ADDENDUM NO. 2

Whiteland Community High School Phase 2A
300 E. Main Street
Whiteland, IN 46184

PROJECT: Whiteland Community High School Phase 2a

DATE OF ADDENDUM: May 2, 2024

SHEET 203

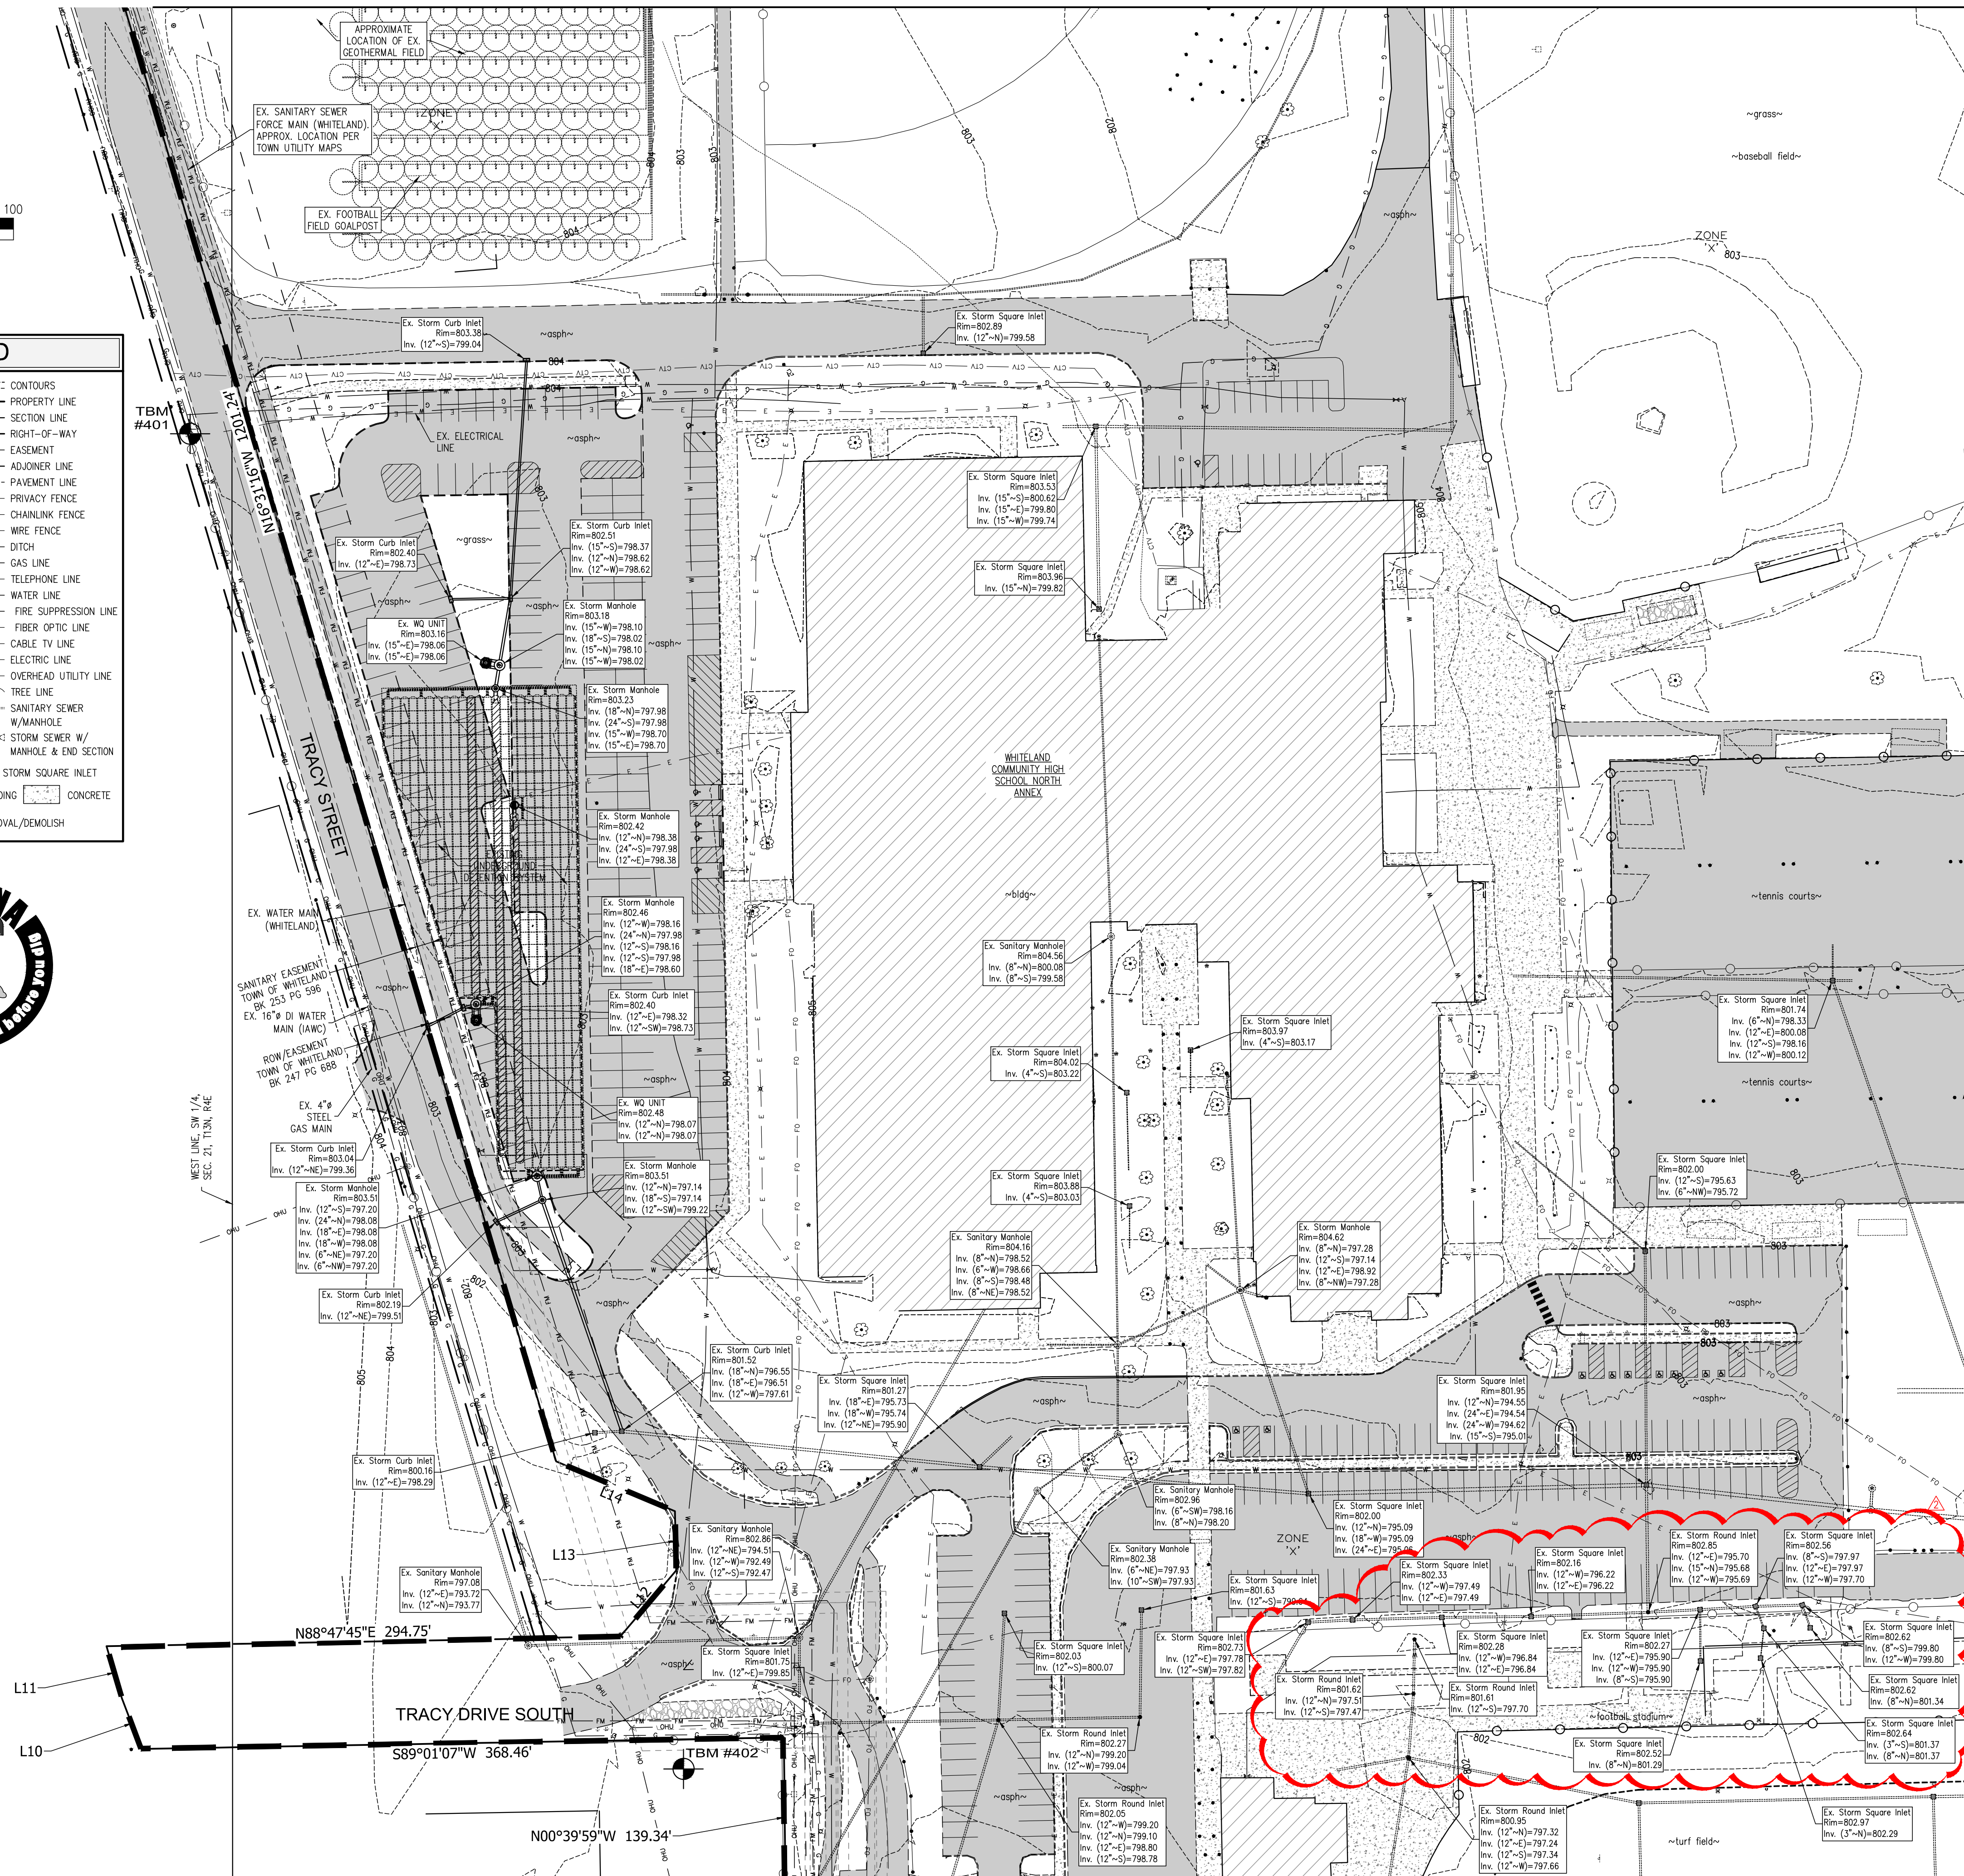
1 Topographical Survey (sheet 203):

- o Revised to include existing inlets north the north football stadium bleachers and existing parking lot.

SHEET 210

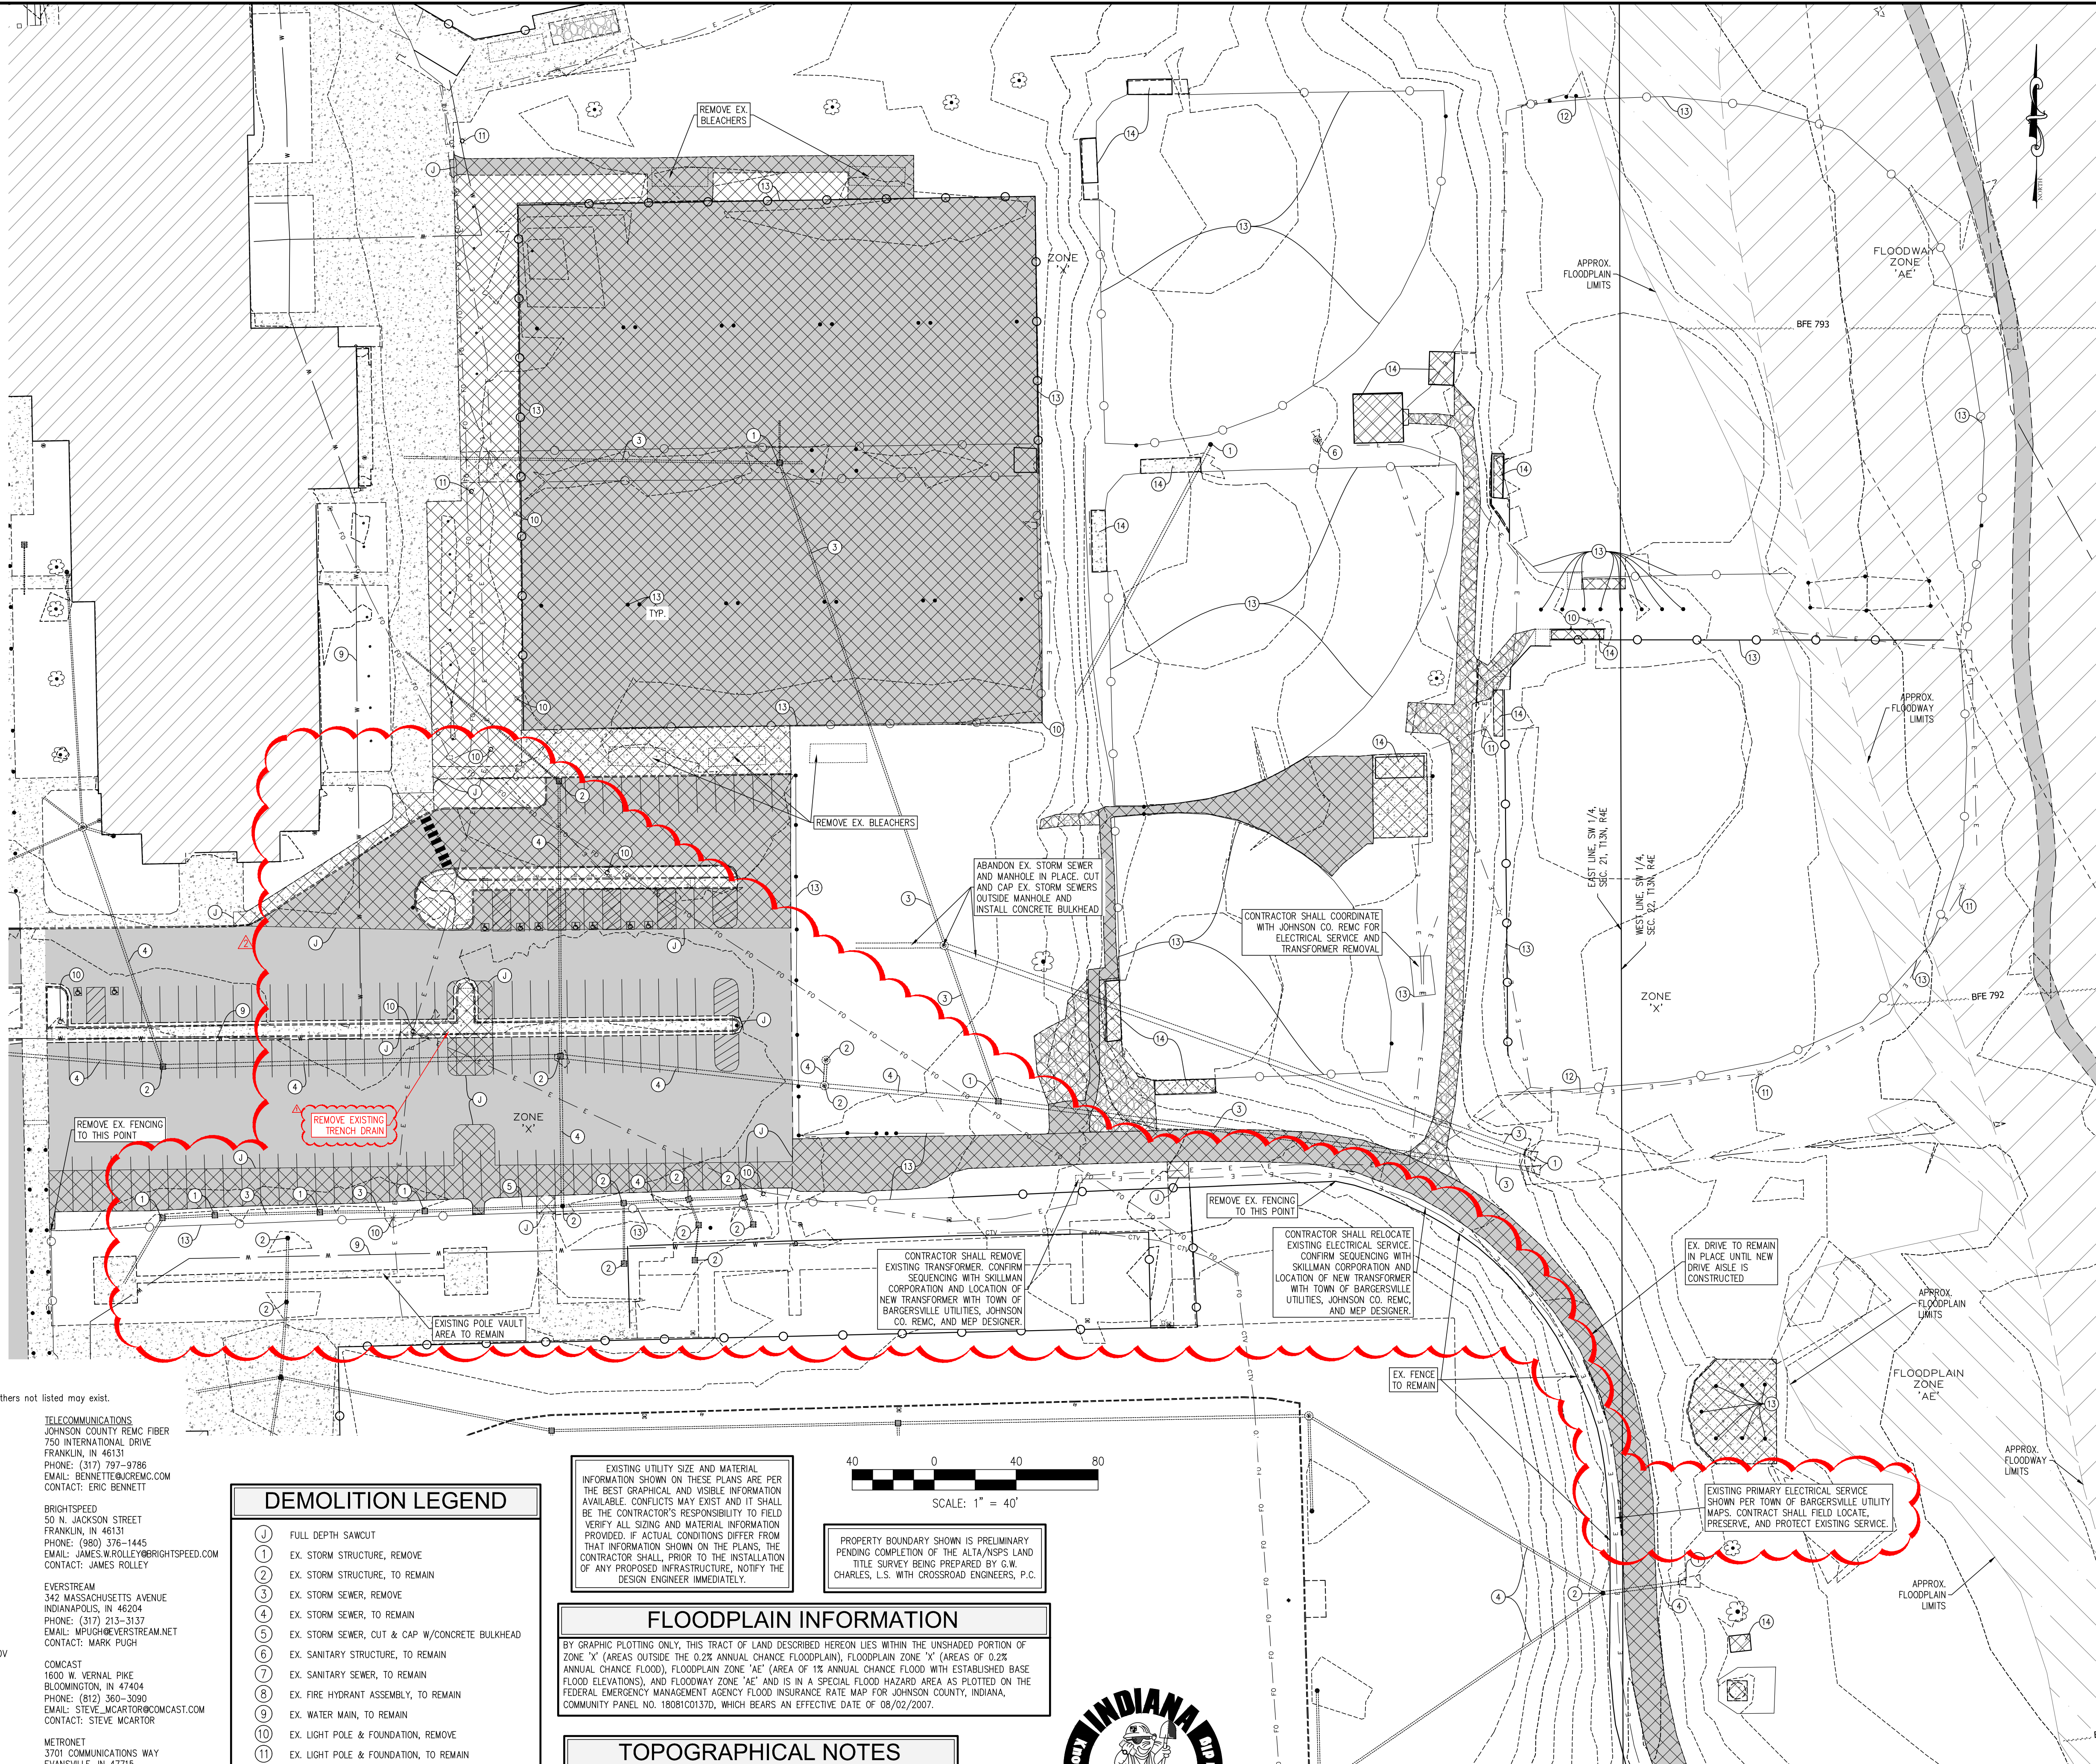
2 Demolition Plan (sheet 210):

- o Revised to include demolition of existing inlets near revised long jump pit location in the northwest corner of the football stadium.

- o Revised to show existing primary electric service to the football stadium bleachers per Town of Bargersville utility maps and existing fiber optic line.

- o Revised to indicate that the contractor is responsible for relocating the existing transformer and electric service for the football stadium north bleachers.

JOB NO.	DRAWN	KLF	CHECKED	TEN	DATE	DESIGNED	DMS	APPR.	GJJ	SHEET	211
					APRIL 02, 2024

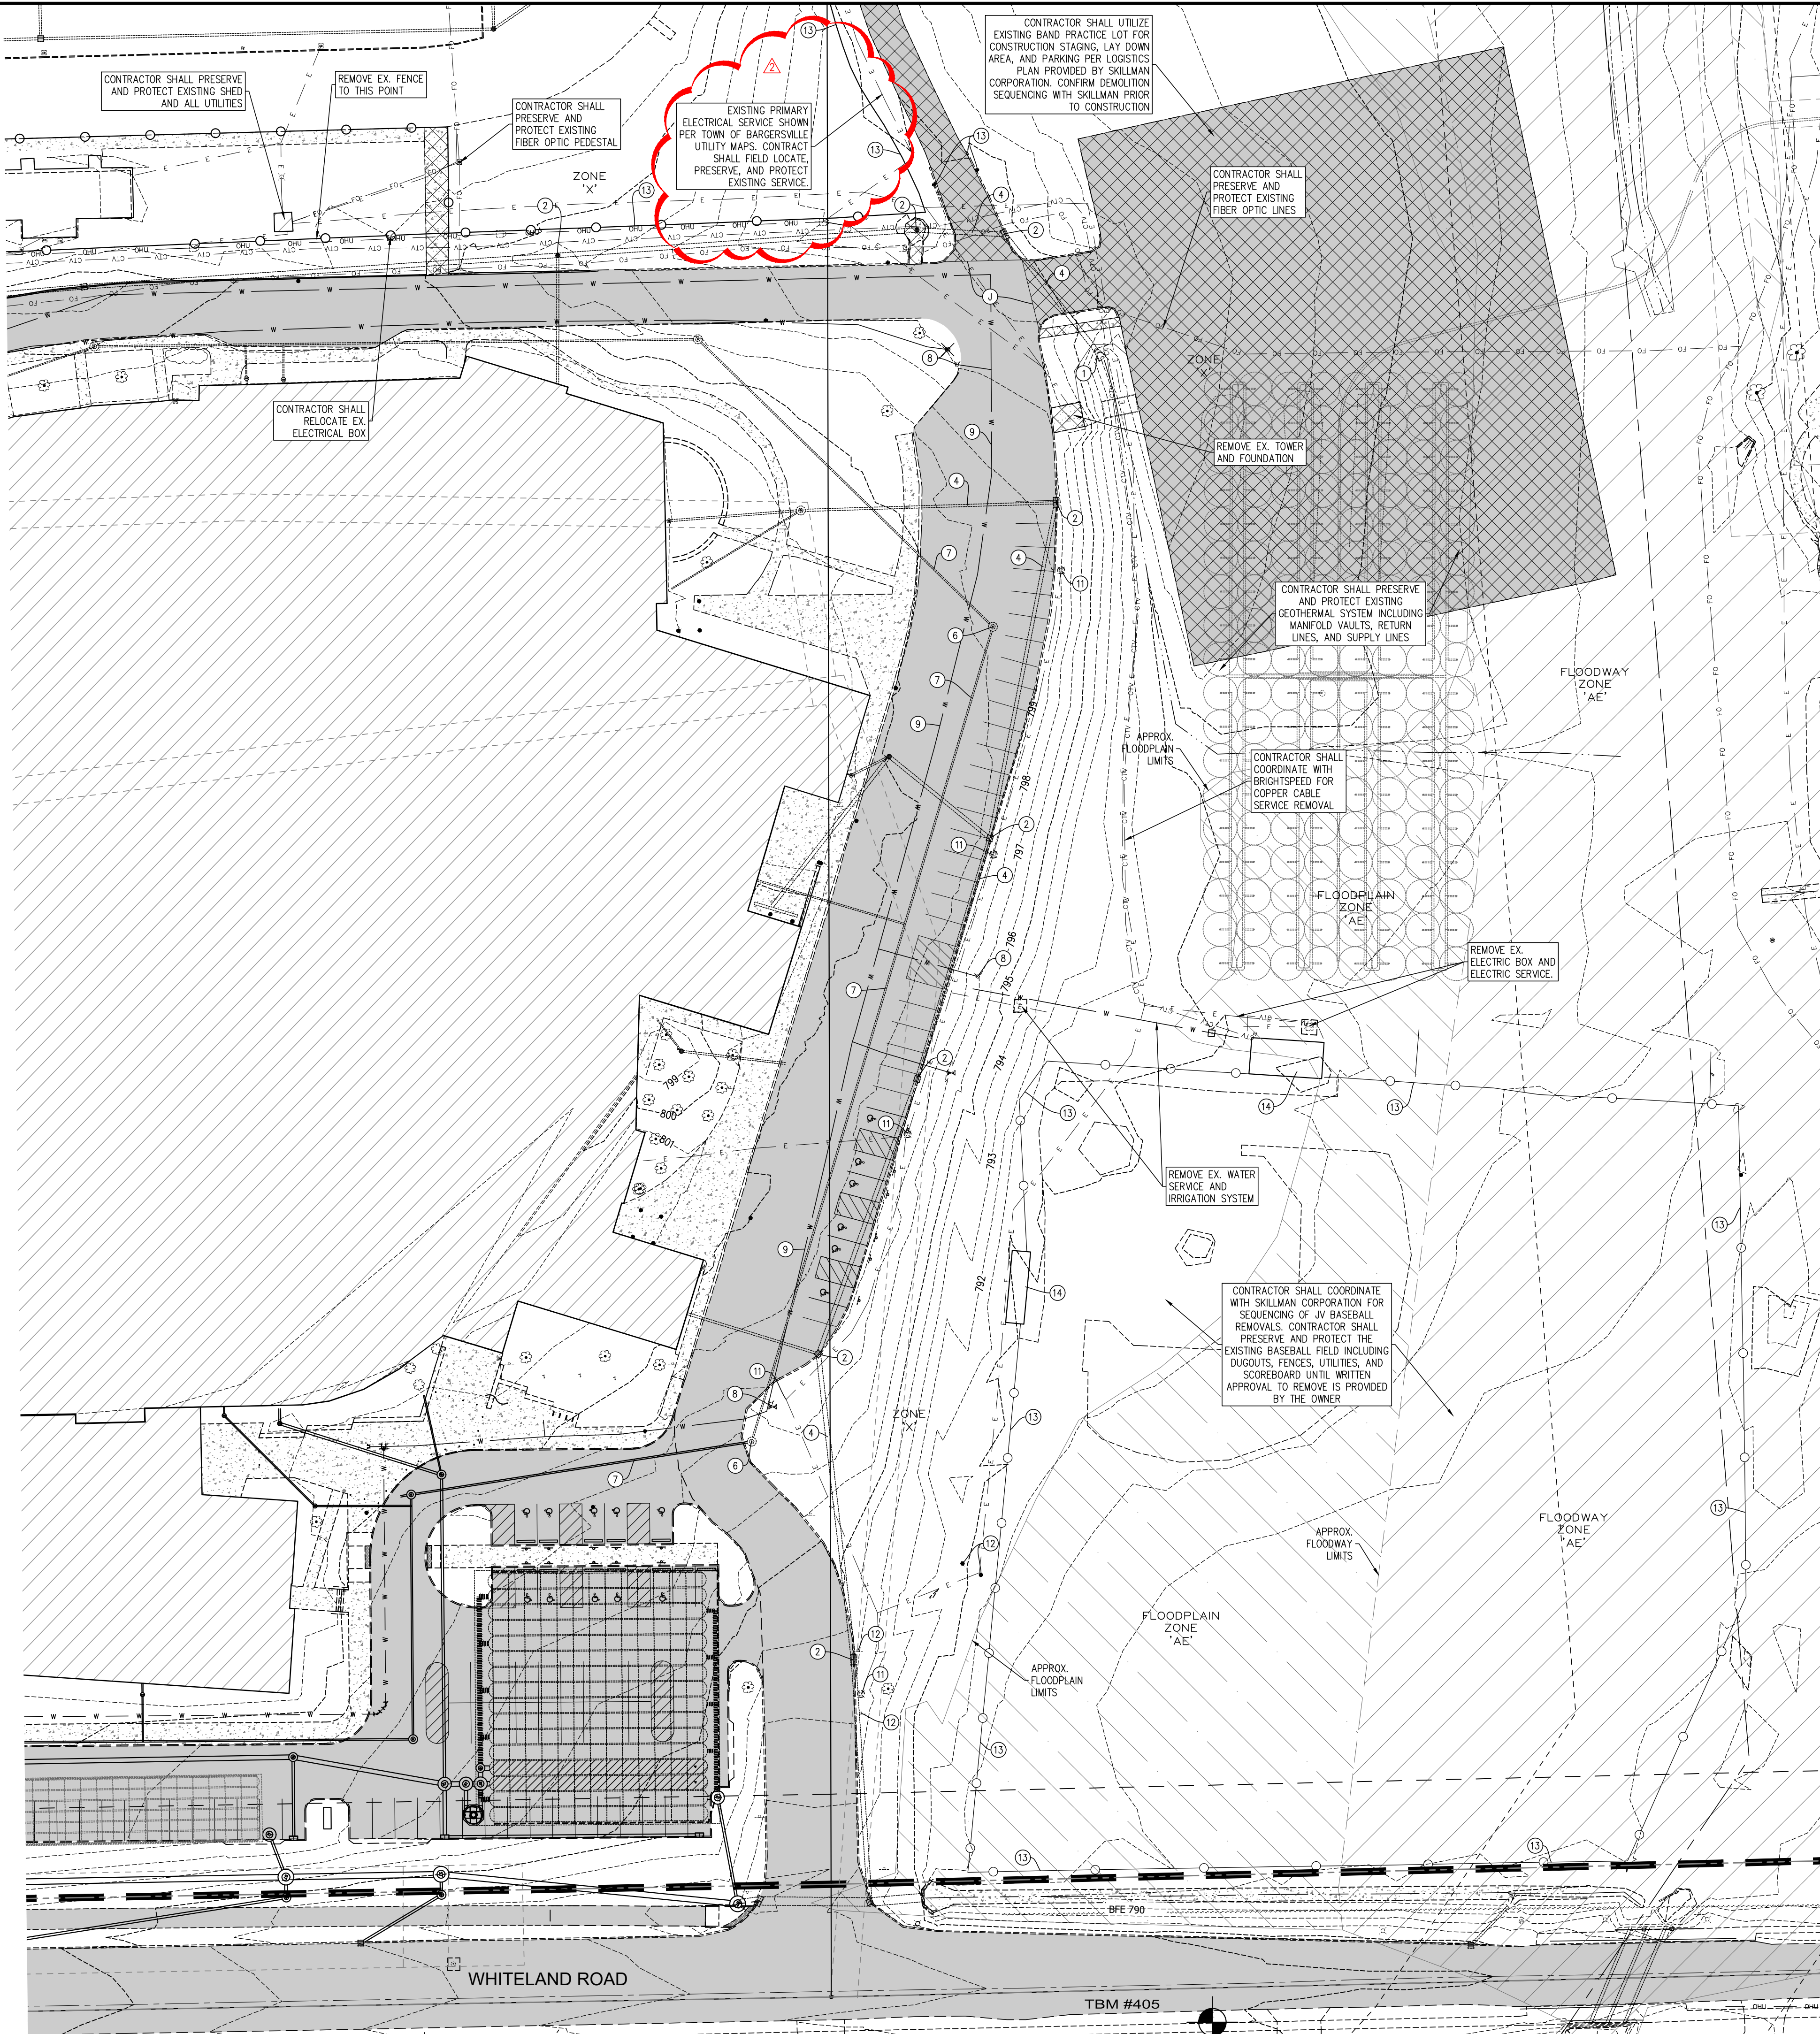
3 Demolition Plan (sheet 211):

- o Revised to show existing primary electric service to the football stadium bleachers per Town of Bargersville utility maps.
